**RECORD NO.:** PLAT-25-000032 (S245-196) **SENIOR PLANNER:** Sharmila Shrestha**LOCATION:** Jim Miller Road, south of Elam Road**DATE FILED:** June 13, 2025**ZONING:** R-7.5(A)**CITY COUNCIL DISTRICT:** 8**SIZE OF REQUEST:** 0.410-acres**APPLICANT/OWNER:** Marcer Construction Company, LLC

**REQUEST:** An application to create one 0.205-acre (8,934-square foot) lot and one 0.205-acre (8,946-square foot) lot from a 0.410-acre tract of land in City Block 6262 on property located on Jim Miller Road, south of Elam Road.

City Plan Commission Date: 07/10/2025      24(g)      **PLAT-25-000032 (S245-196)**

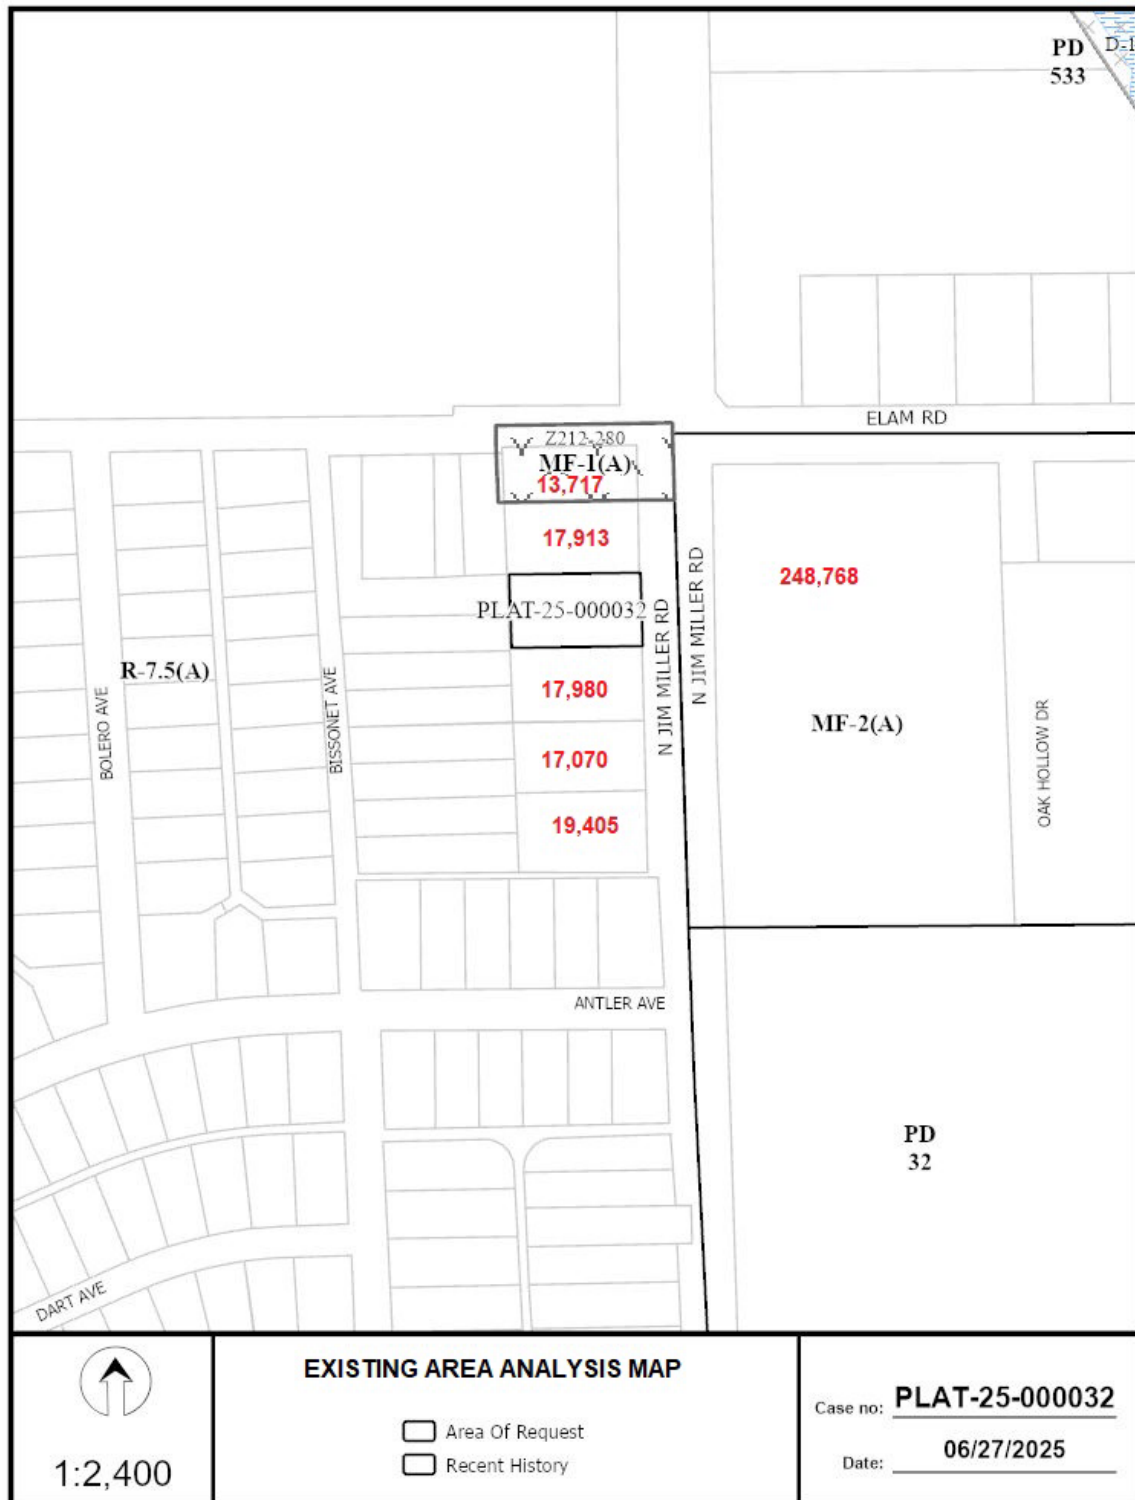
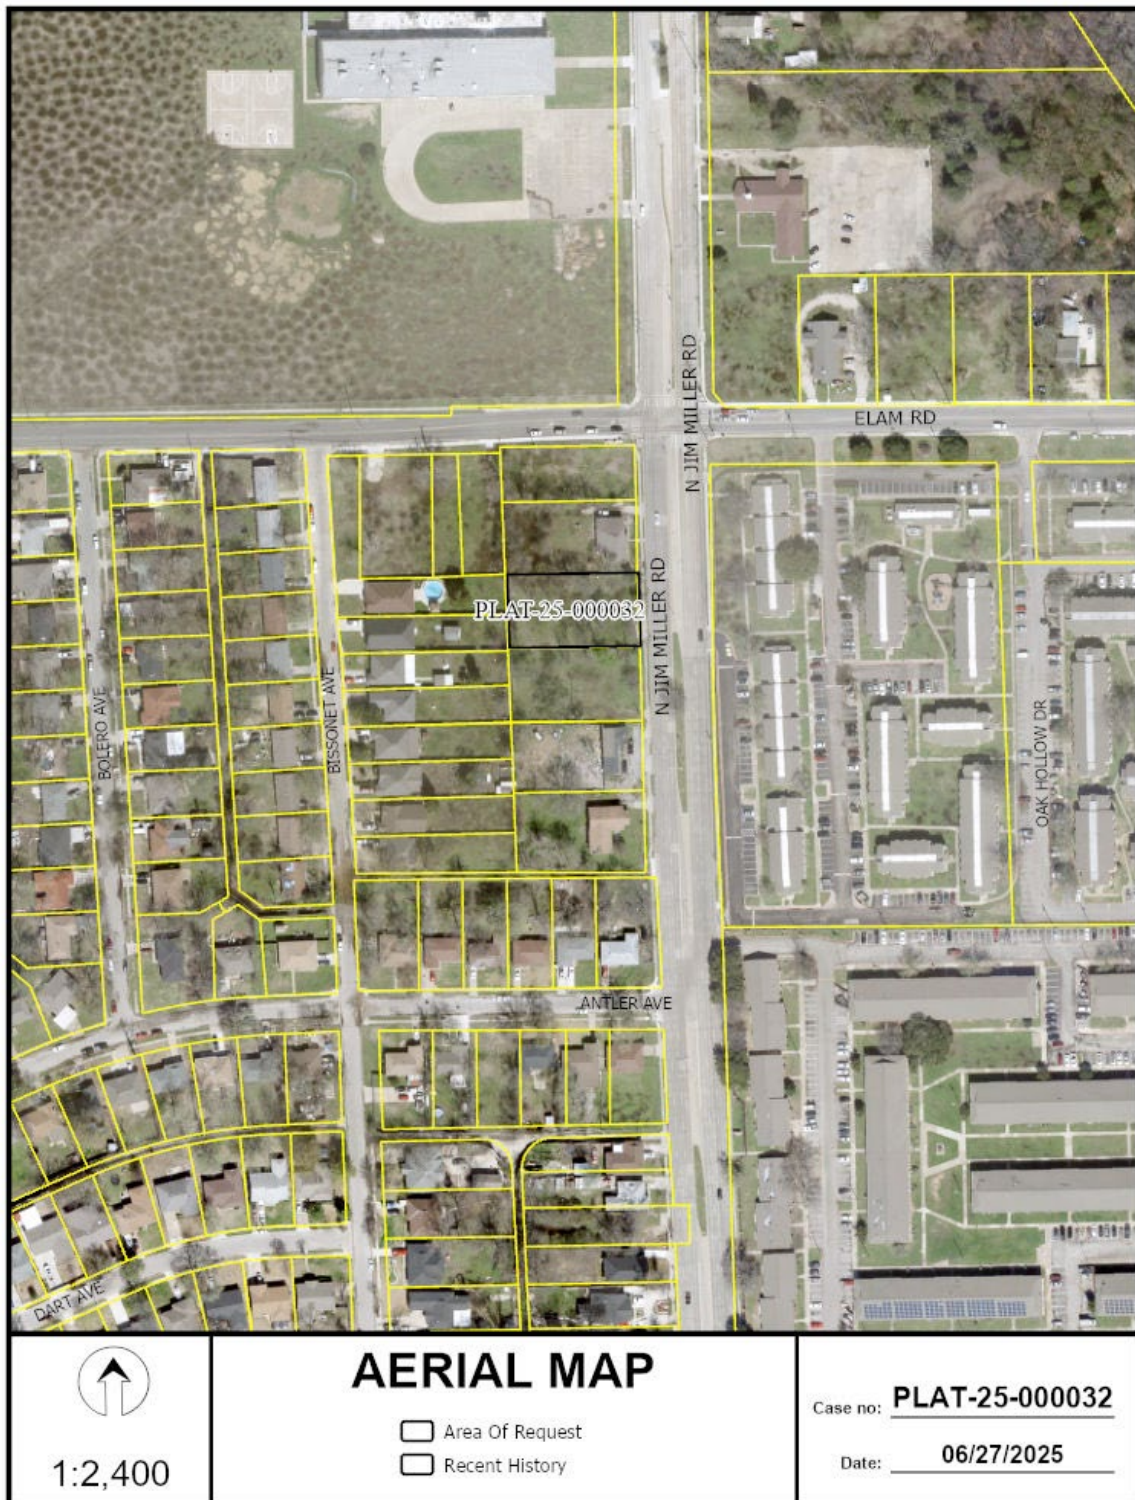
18. On the final plat, change “Jim Miller” to “Jim Miller Road”.
19. On the final plat, identify the property as Lots 19 and 20 in City Block 5/6262.
